ENDL TEXAS

Date: 9 June 2008
 To: SNIA OSD TWG and T10 Technical Committee
 From: Ralph O. Weber
 Subject: OSD-2 CDB Continuations Definition and Usage

Figure 4 — OSD security model transactions

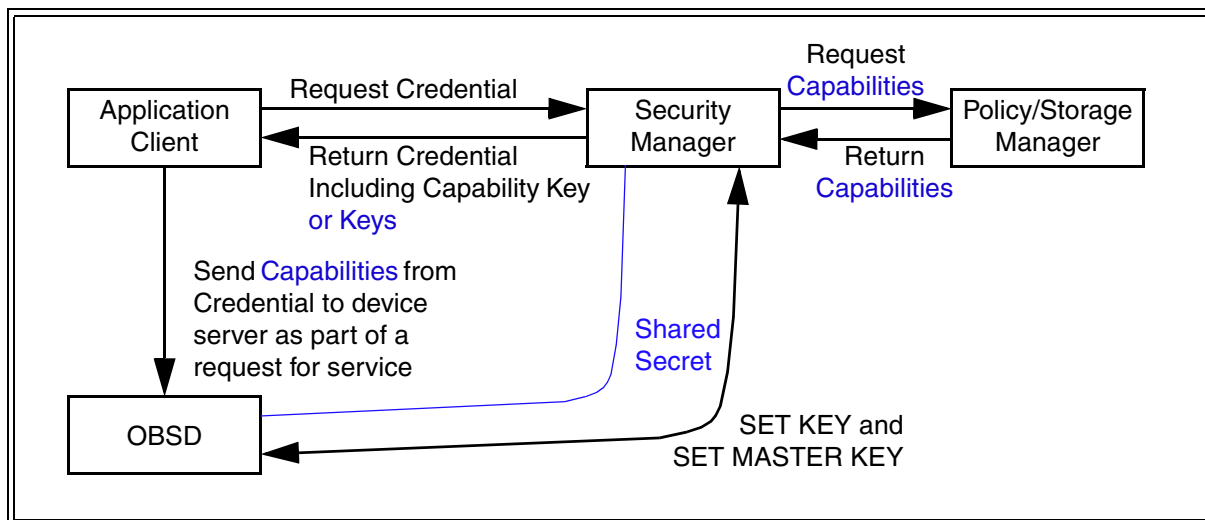
{{With the exception of 'Shared Secret', all the blue text in figure 4 is a replacement for existing text. To keep figure 4 manageable, strikeouts are not show for the old text.}}
